3070-83

**S E R V I C E N O T E**

Agilent Medalist i3070 and i3070 Series 5 In-Circuit Test System

**Preventive Measures to Minimize Lost Heartbeat Errors**

**Forcing 10 Mbps Half Duplex on Testhead LAN**

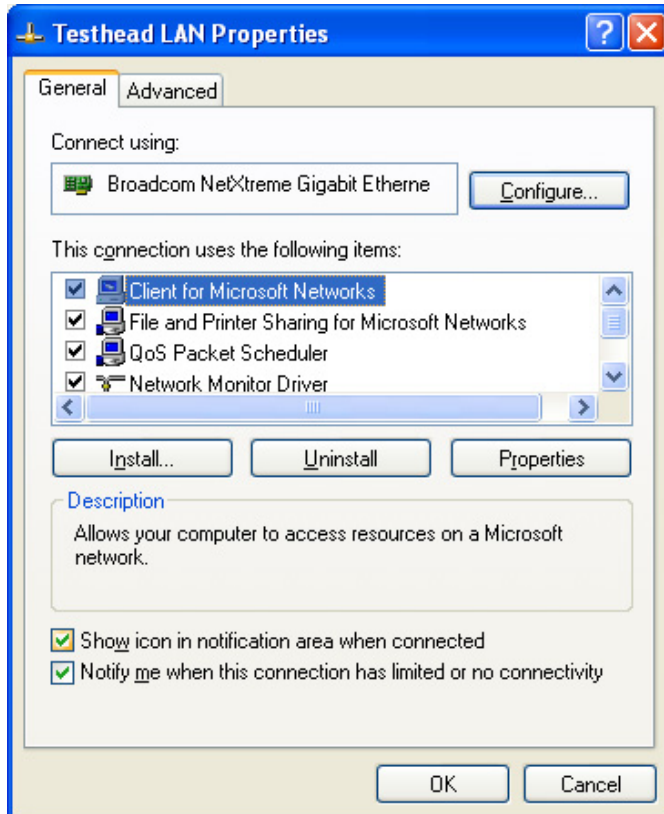
Explicitly set the private i3070 Testhead LAN for the controller to “10MB/half-duplex”, instead of using the “Auto” setting.

This is recommended for any Medalist i3070 or Medalist i3070 Series 5 system (whether it has the System Card or i-System Card) that is connected to the private Testhead LAN network with LAN switches.

1. Right-click on the Testhead LAN icon in the Taskbar and select **Status**.

2. In the Testhead LAN Status dialog box, click **Properties**.
3. In the Testhead LAN Properties dialog box, click **Configure**.

4. In the network adapter Properties dialog box, click the **Advanced** tab.
5. Select the **Speed & Duplex** property and change its value to **10 Mb Half**.
